Date October 13, 2015
To Town of Medway Planning & Economic Development
From Dario Designs Inc. and Coneco Engineers & Scientists
Project Salmon Health & Retirement Community
Subject Response to Town Comments

All of the drawings referred to above can be found in the “Salmon Health and Retirement Community ARCPUD Special Permit Site Plans” set dated June 12, 2015 Revised October 13, 2015. See attached Cover Sheet for the drawing list. *(SEE EXHIBIT F)*

Photo 1 (looking south)
30'' diameter Ash Tree to be removed

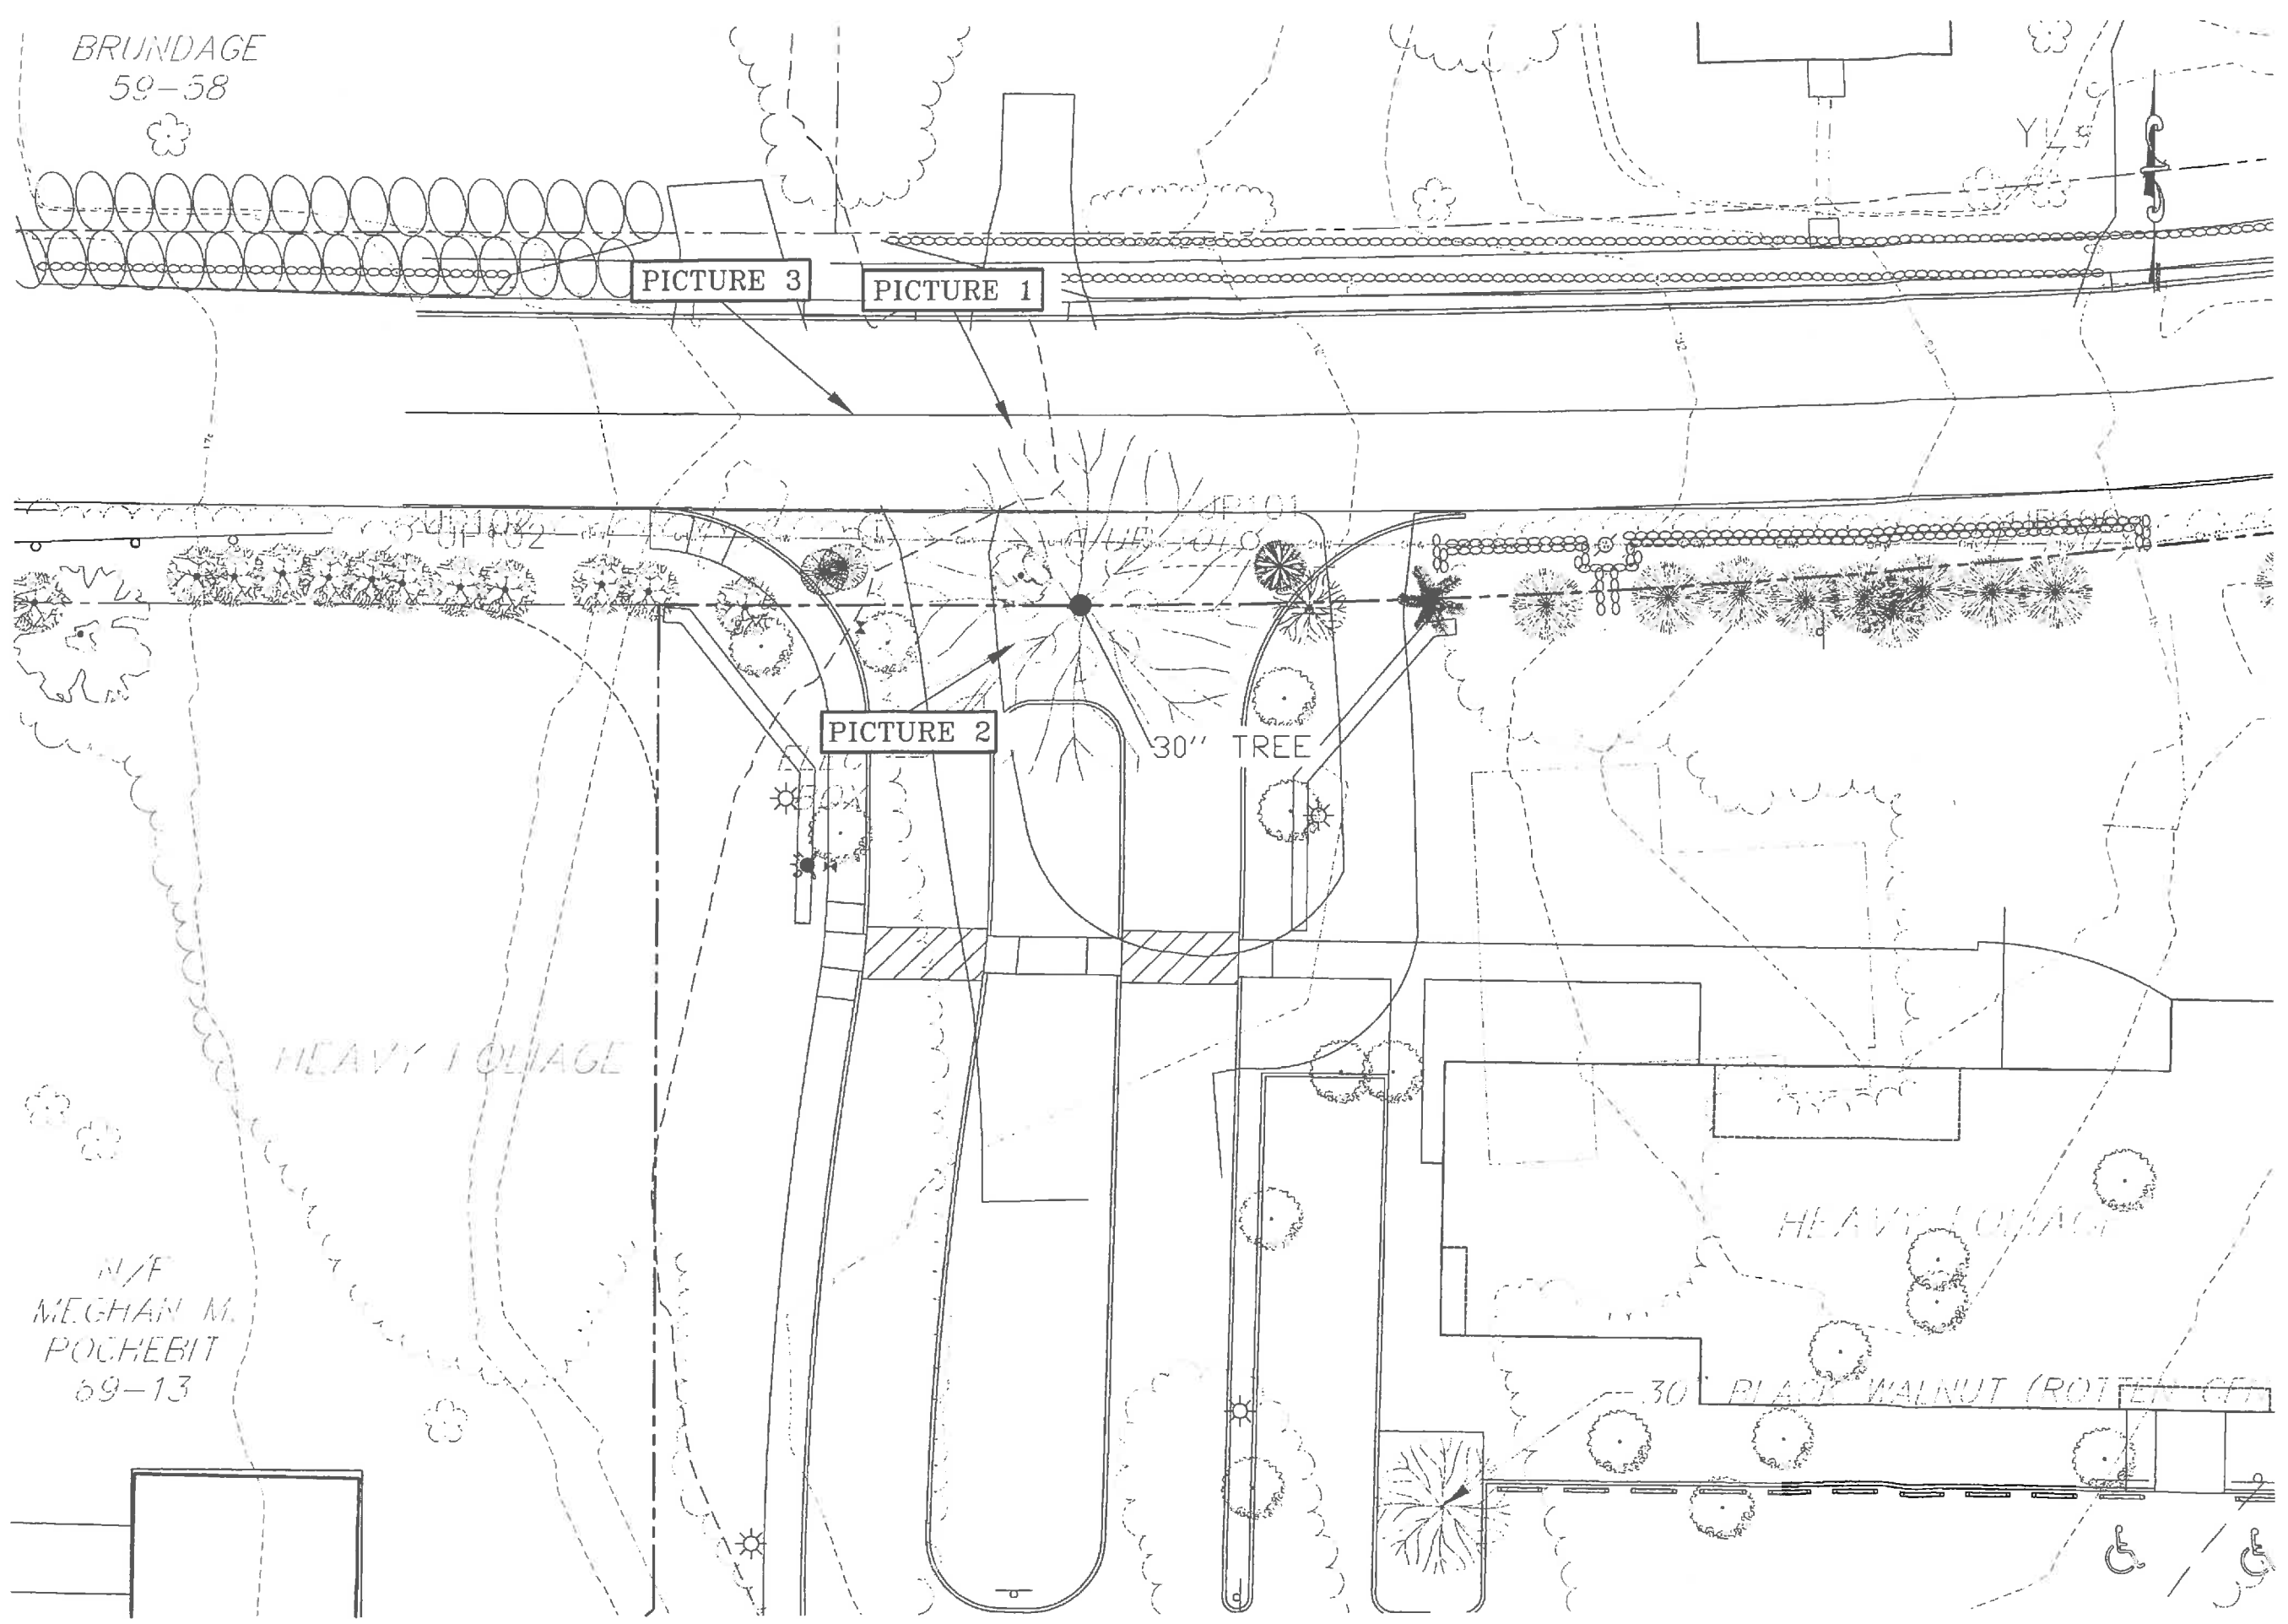
2. There is one 30” ash tree located in the Town’s right-of-way adjacent to 263 Village Street that is proposed for removal. It is located exactly where the primary roadway (Willow Pond Circle) from Village Street into the development would be constructed. See attached photos and the Scenic Road Permit Application plan dated 7/23/15 prepared by Coneco Engineers and Scientists. No stone walls in the Town’s right-of-way are affected.
3. The planned roadway location was selected in part to preserve as many black walnut trees on the development site as possible. The grove of black walnut trees is an important natural resource of the development site which the Board and the Conservation Commission wish to preserve.
4. Section 405-8 B of the *Scenic Road Rules and Regulations* provides for tree replacement on a 1 sq. inch per 2 sq. inch replacement basis as follows:

The first proposed access is located on the south side of Village Street in the north-west corner of the subject parcel. This access will be a boulevard style entrance approximately one hundred feet wide and will require the removal of one tree which is within the jurisdiction of the Town of Medway's Planning Board Rules and Regulations Chapter 400-Scenic Roads. The tree is an ash tree approximately thirty inches in diameter with all of its branches hanging over the applicants parcel as a result of limb cutting within the Right of Way for power line clearance [Pictures 1-3]. This tree lies approximately fourteen feet from the edge of the pavement; placing the tree along the property line. This tree can be seen in figure 1 called out as a 30" Ash Tree.

The existing ash tree which falls within the jurisdiction of Town of Medway's Planning Board Rules and Regulations Chapter 400-Scenic Roads must be removed not only for roadway construction, but to provide vehicles entering and exiting the community adequate sight distance to safely traverse the intersection. Additionally, the tree has minimal aesthetic value to the roadway corridor since it no longer has any branches on the street side due to previous maintenance. As shown in the pictures, currently it is very difficult to see the tree from the roadway due to maintenance and the existing setback from Village Street.

| SALMON HEALTH AND RETIREMENT COMMUNITY 269, 281, 281B AND 285 HILLOE STREET MEDWAY, MASSACHUSETTS 02053 | | SHEET 2 OF 6 SITE LAYOUT |

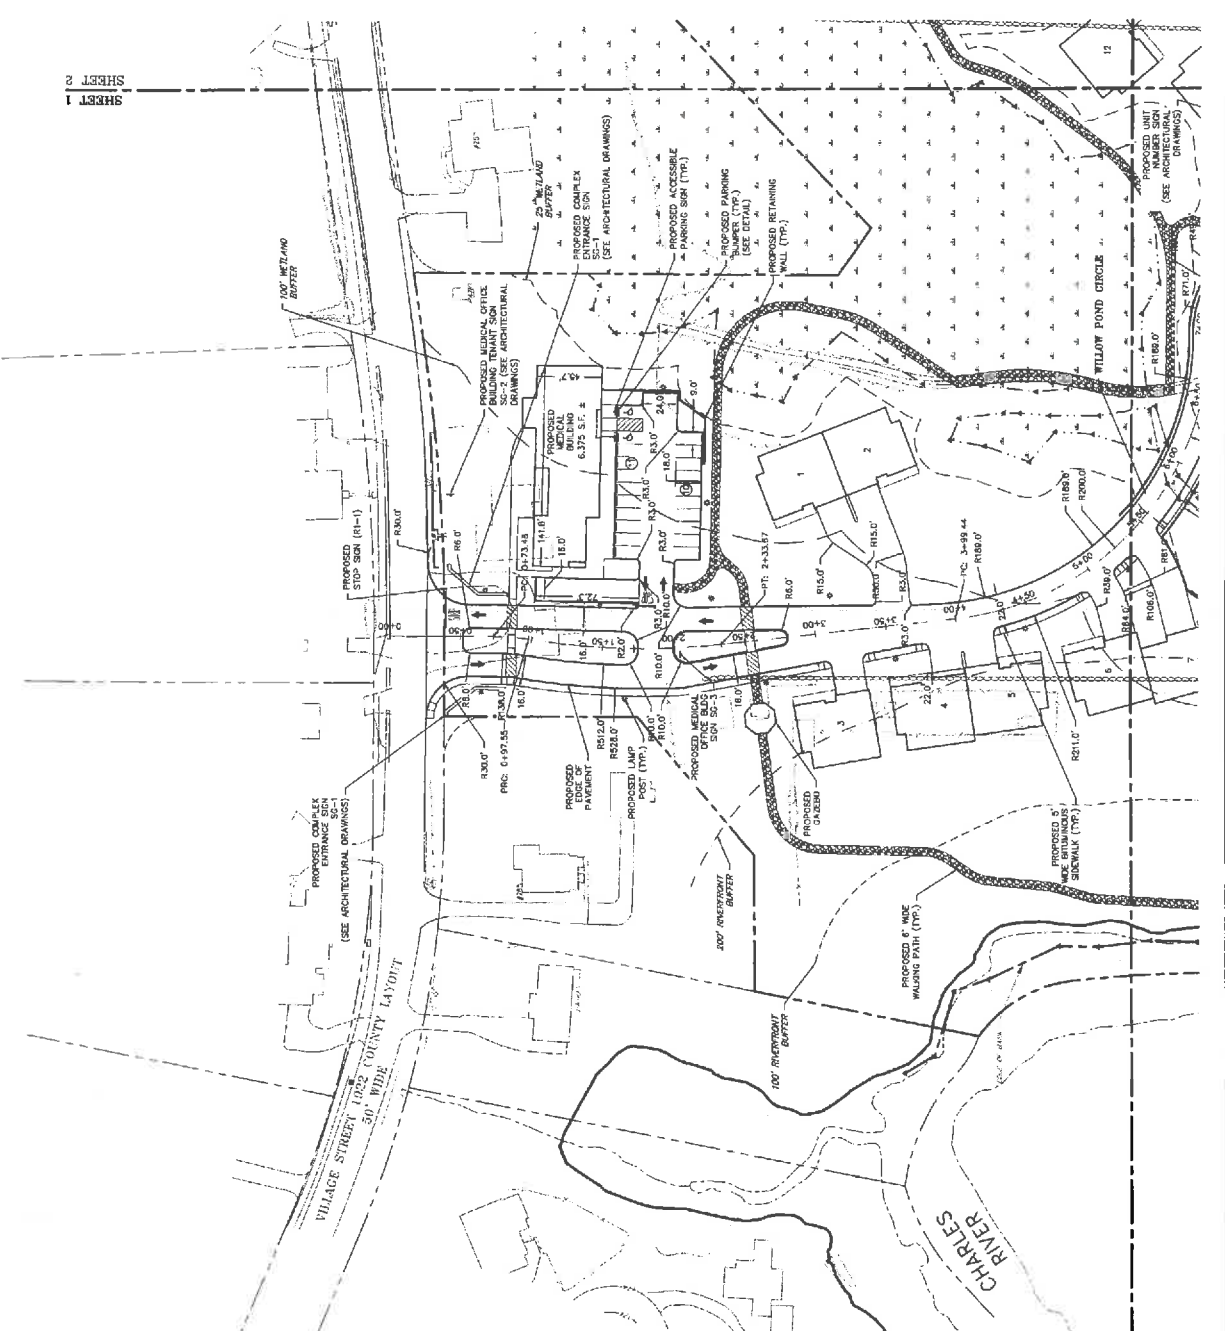
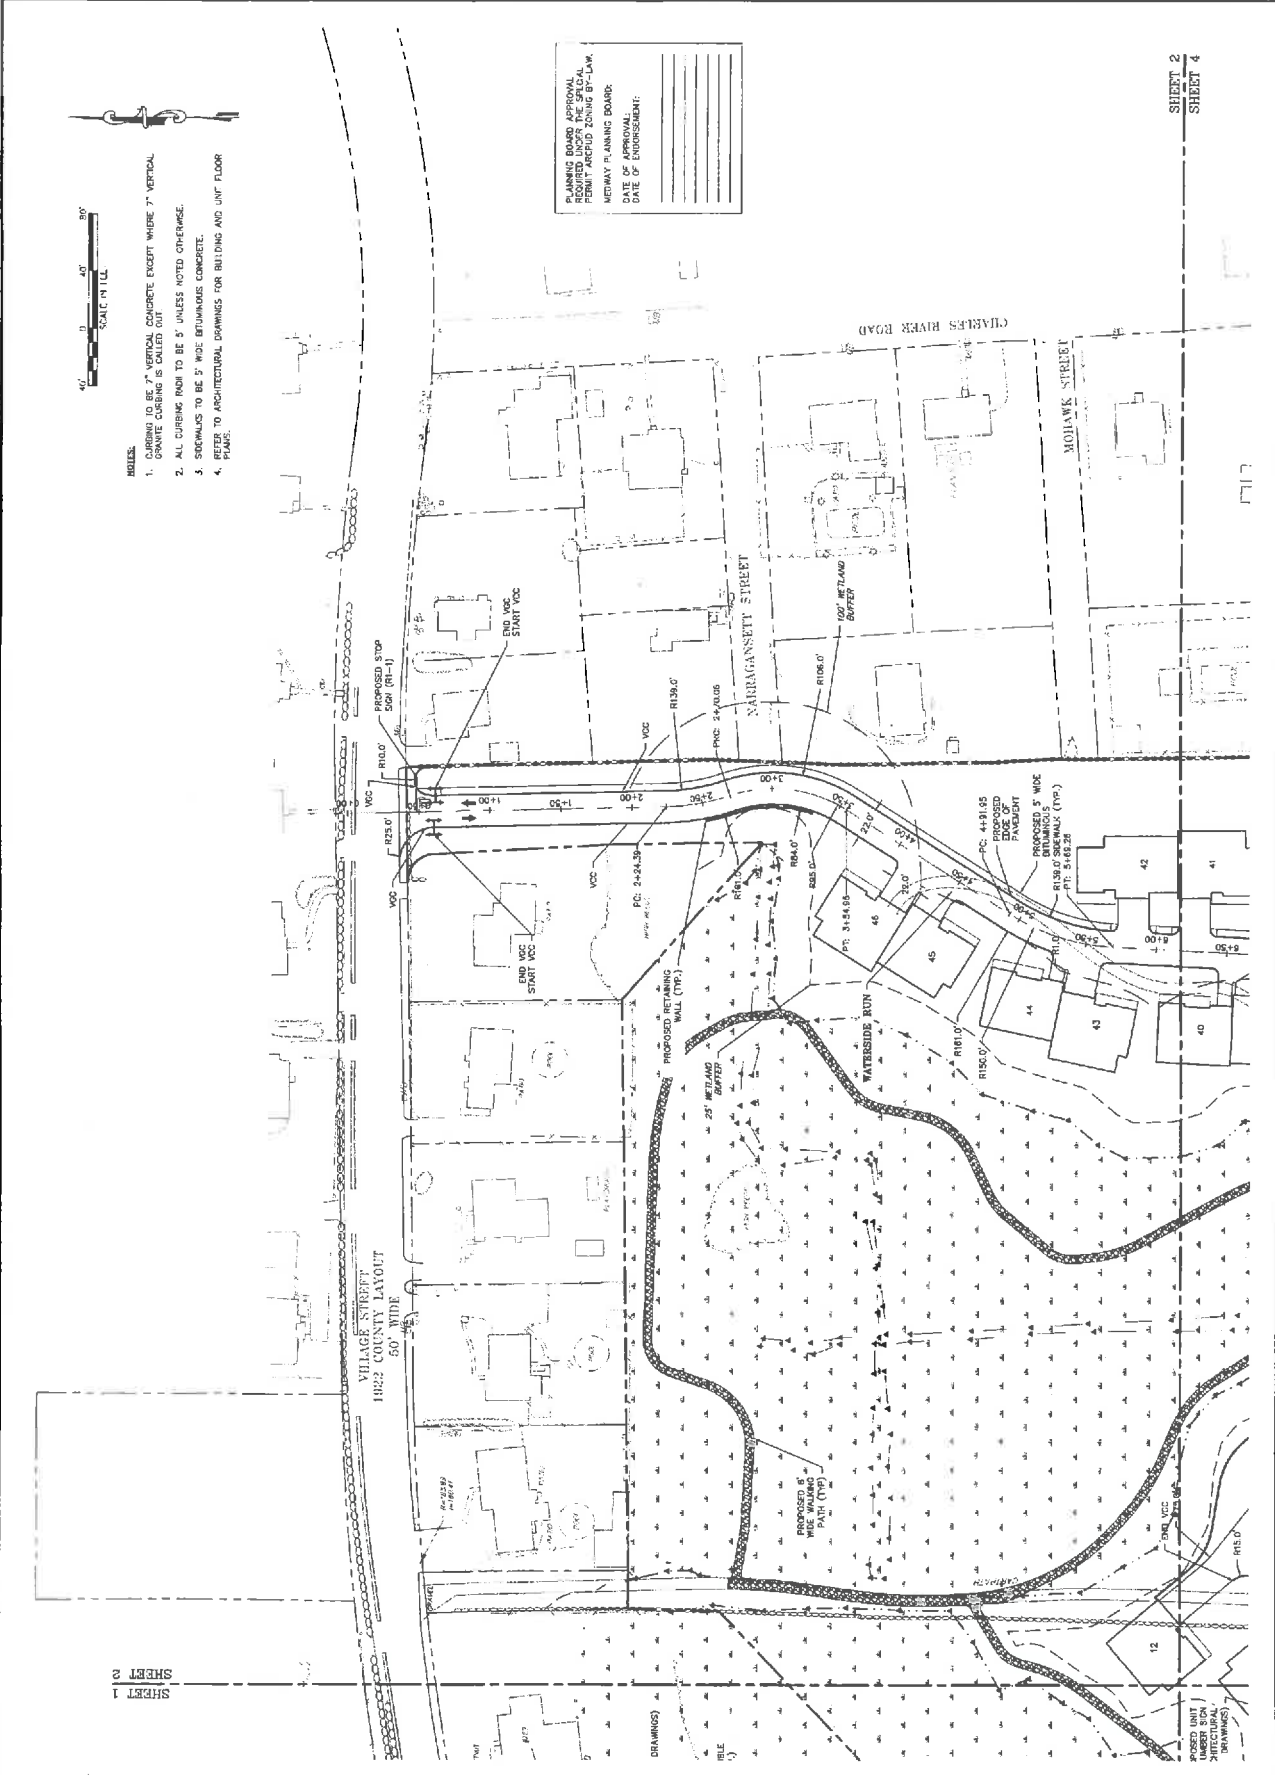
- 1. At the present time there is no information regarding the separation distances of the duplex houses. Separation distance should be a minimum of 30 ft. This Standard is not statutory, however does conform with industry's best practices. I have met with the architect for this development and he has agreed to fire rate exterior facing walls on buildings that are within 10 feet of each other. I feel that this will give adequate fire separation for these buildings, and will comply with the intent of the Standard.
DDI: As the design progresses, any buildings within 10 feet of each other will have 1 hour exterior walls. See Civil drawing, Site Plan Layout, for location of cottages under 10 feet.

11. ARCUD Rules and Regulations Comment 18a. The roadway and other infrastructure systems should be linked to and coordinated with surrounding off-site infrastructure. The sidewalk network within the site is well-designed and extends out to Village Street. However, there is no sidewalk on the same side of Village Street as the project site. Consideration should be given to add an enhanced crosswalk, perhaps with a lighted warning system, to connect with the sidewalk on the other side of Village Street.
CES: Two crosswalks have been added. See Civil Site Layout Plan.

19. Street Opening Permit Requirements will govern Village Street access areas. Sight line considerations should be no issue but worth getting PD opinion. Signalized crosswalk from development to north Village Street sidewalks might be a good idea.
CES: See crosswalks on Civil Site Layout.
